Product Change Notification - SYST-07AFZV254

ERRATA - SAM D11 Series Family Silicon Errata and Data Sheet Clarifications

SAM D11 Series Family Silicon Errata and Data Sheet Clarification

FIGURE 35-3: BOD33 HYSTERESIS OFF

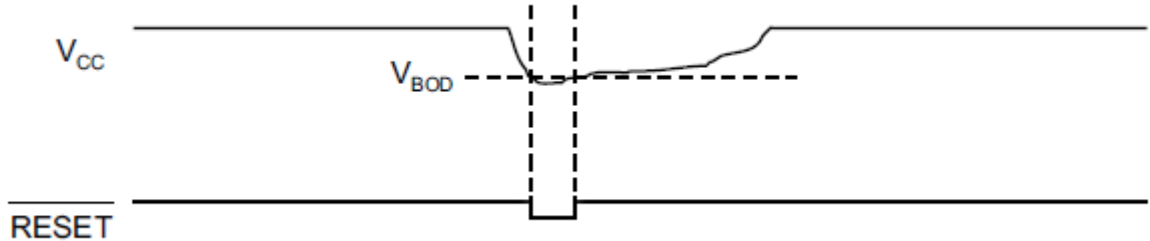
4. Module: Brown Out Detectors Characteristics

Figures 35-3 and 35-4 have an incorrect reset Polarity value. The correct figures are displayed as follows:
